SECTION 4.55 (\$4.55) AMENDMENTS TO DA APPROVAL DA2022/1715 SHOWN BUBBLED IN RED.

Project:
ALTS & ADS TO EXISTING HOUSE
60 HUDSON PDE, CLAREVILLE NSW 2107

Drawing Name:
SITE PLAN

Drawing No:
DA_003

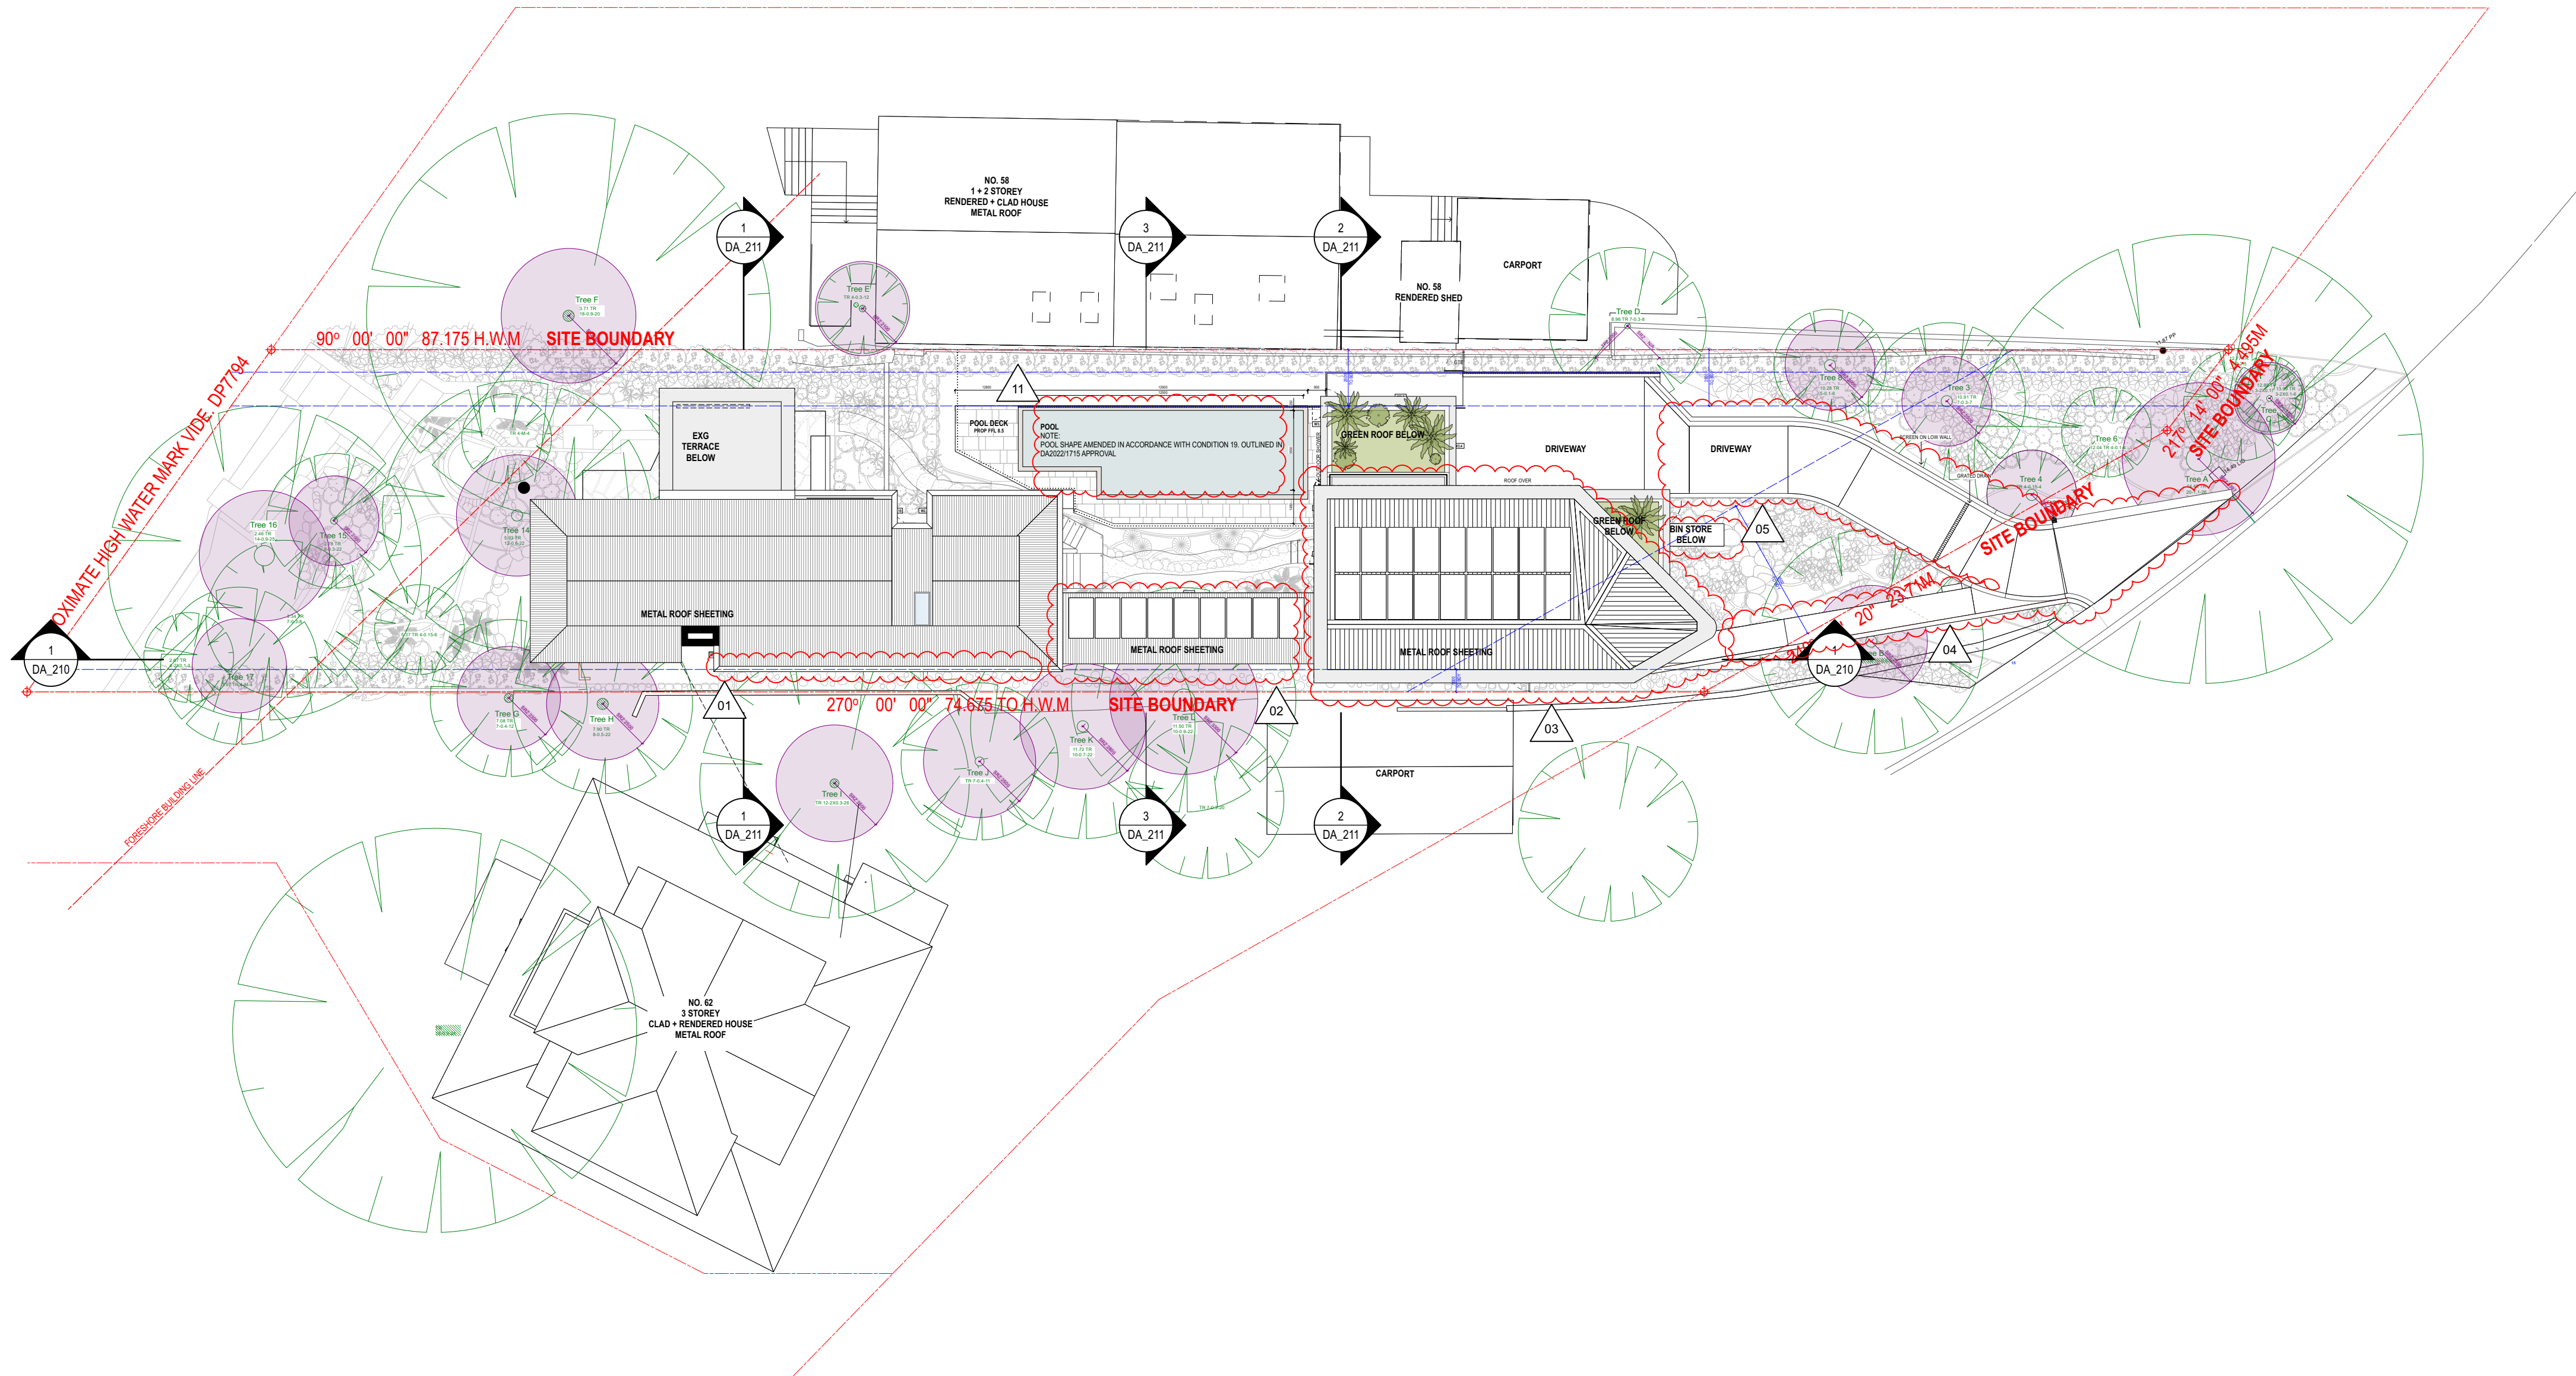
- SCHEDULE OF KEY AMENDMENTS:**
- 01 SOUTHERN ELEVATION WINDOW ARRANGEMENT & WALL LOCATION
- 02 GALLERY LOCATION AND ROOF ORIENTATION
- 03 PAVILION ROOF FORM
- 04 DRIVEWAY AND ENTRY PATH CONFIGURATION INCLUDING NEW SCREEN.
- 05 BIN STORE LOCATION
- 11 POOL SHAPE AMENDED IN ACCORDANCE WITH CONDITION 19, OUTLINED IN DA2022/1715 APPROVAL. THIS INCLUDES A DIRECTIONAL PRIVACY SCREEN AT A 45 DEGREE ANGLE ON TOP OF THE POOL WALL.
